WILD PLANET ENTERTAINMENT, INC.

Ref: 46001 Hyper Dash - Change of circuit for FCC and RSS210

46001 Hyper Dash schematic of Reader (Modified)

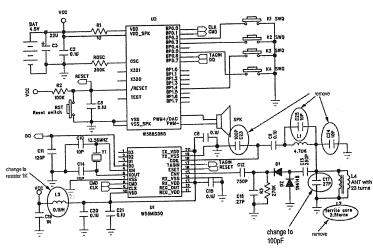
We would like to simplify the design of Reader of 46001 Hyper Dash in order to save manufacturing cost. The previous certified model 46001 with FCC ID: N3EHYPERDASH46001 and IC Certification number: 3675A-46001 has been modified and the details are listed in below. The PCBs remain unchanged. The modifications do not intend for change in maximum power, field strength ratings and operating frequency. The functions of the modified model are the same as previous certified model.

- 1. remove ferrite core L2
- 2. remove capacitors C23, C24 and C25
- 3. change capacitor C17 from 27pF to 100pF
- 4. change coil L3 to 1K ohm resistor
